File: 2014-4531.000.E.400

**Re: TOWN OF VIRDEN WWTF
NOTICE OF ALTERATION**

In accordance with the Environment Act (Section 14), this submission is a request for a minor alteration to the new Licence being prepared for the Town of Virden Wastewater Treatment Facility (WWTF).

Viriden BOD Results

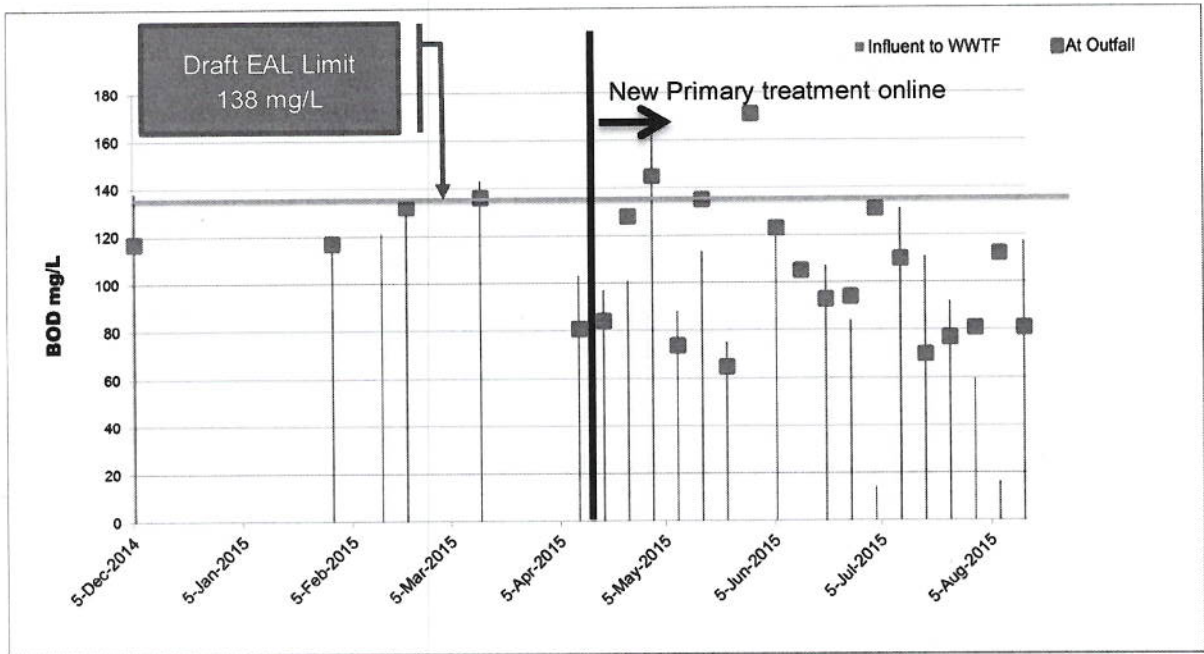
As additional information, included are the lab summary results from December 2014 through to August 2015. The results show that in general the new primary treatment process is performing as expected with a moderate reduction in TSS and a minor reduction in BOD through the process.

Viriden Fecal Results

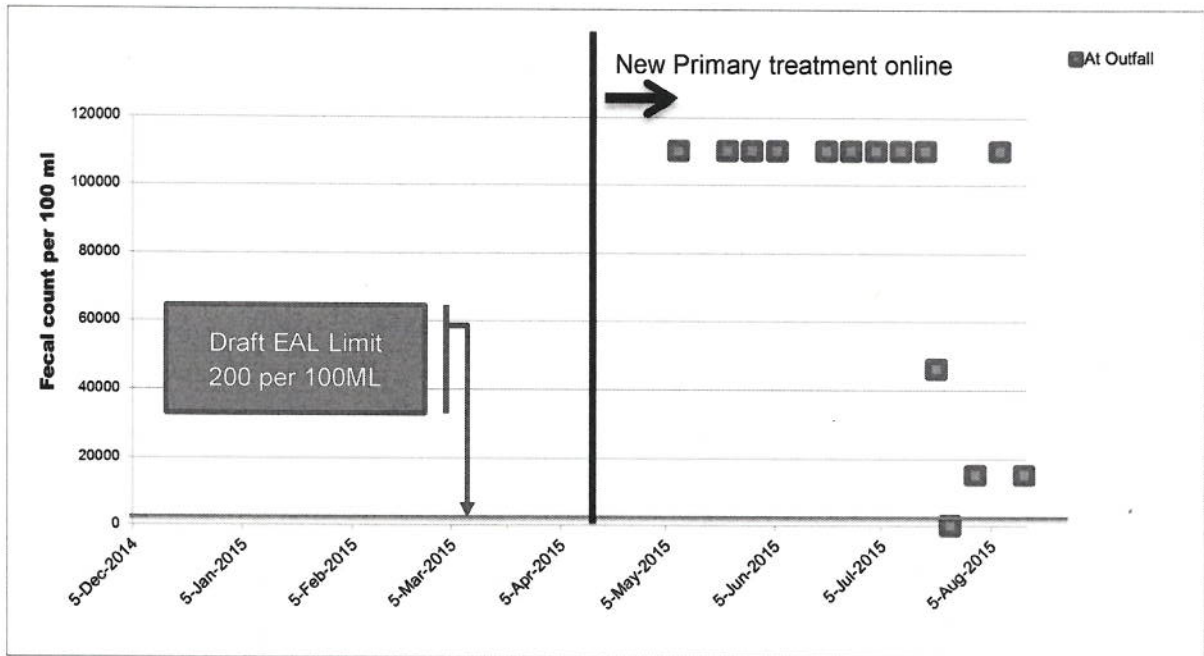
Over the last several months the Town has been trying to increase chlorine dosage to reduce the fecal coliform content of the effluent. At one point they were dosing nearly two 250L barrels per day and the fecal concentration was only reduced to 15,000 to 20,000 per 100 ml. Although there is a sodium bisulfite feed to de-chlorinate prior to the outfall, the Town was concerned with dosing this amount of chlorine into the effluent. It does not seem feasible for the town to achieve the 200 per 100 ml MPN limit with chlorine at this time given that they only have primary treatment in place.

Given that this is only primary treatment, there is no reduction in pathogens to be expected through the Salsnes; this will need to be treated through chlorine addition. The amount of chlorine required to provide sufficient pathogen kill (<200 MPN) is extremely high and concerning to the Town. As the flowing charts show, the Fecal count was reduced to near 230 MPN at one time, but at the cost of two sodium hypo barrels per day. The Town feels this amount of chlorine, even when suitably countered with de-chlorination, can be more harmful to the environment than the elevated Fecal counts. Thus, they are currently dosing a barrel every one to two days.

The Town and MB Conservation will likely need to have further discussion on this issue. With the announcement of funding for Phase 2, it is anticipated that the full treatment system will be in place by early 2017, and the new system will then meet the disinfection targets.
